NUMBER: 14-004-21

Missing Upper Fuel Tank Heat Shield

This bulletin involves installing the upper heat shield on the top of the fuel tank.

2021 (WD) Dodge Durango

Fig. 1

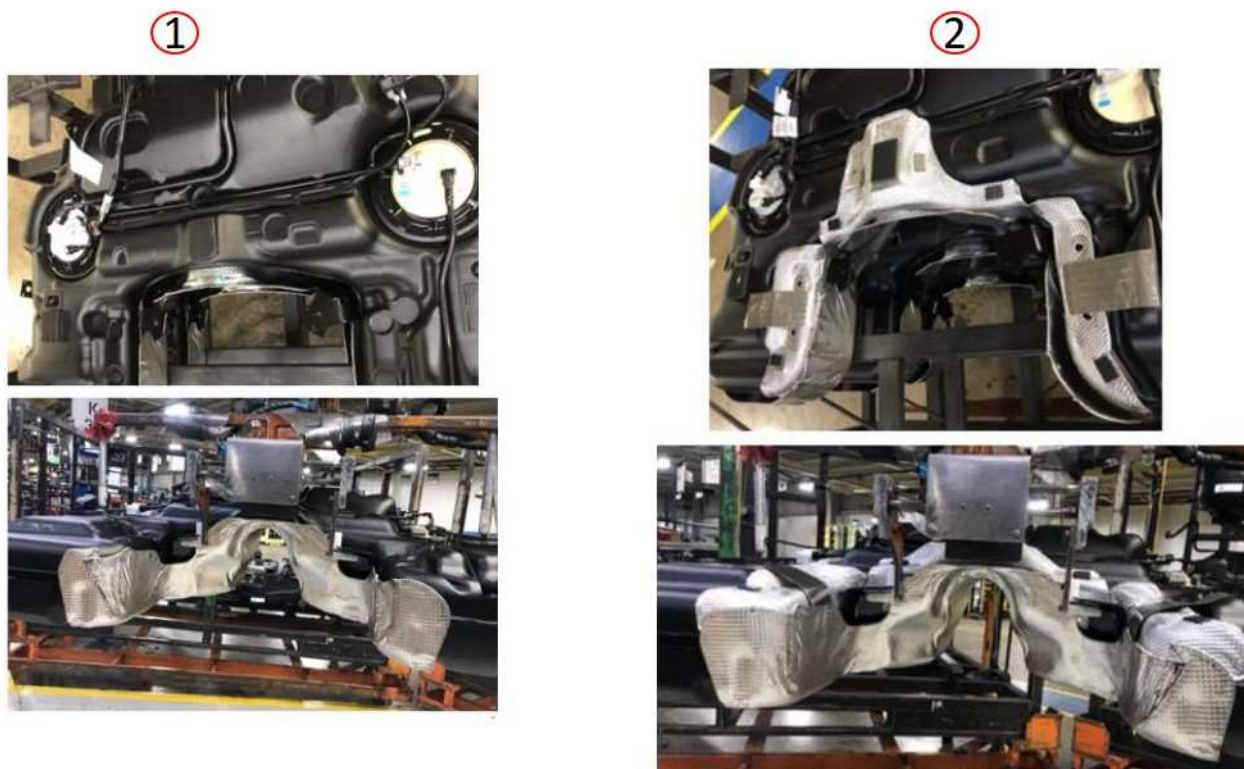
NOTE: Refer to (Fig. 1) for reference on the missing and a correctly installed upper fuel tank shield.

- 1 - Missing Upper Fuel Tank Heat Shield
2 - Correctly Installed Upper Fuel Tank Heat Shield
-

2. Remove the fuel tank. Refer to the detailed service procedures available in DealerCONNECT/Service Library under: Service Info>14 - Fuel System / Fuel Delivery, Gas / Tank, Fuel / Removal.
3. Install the upper fuel tank heat shield with the new part and secure to the top of the fuel tank (Fig. 2) .
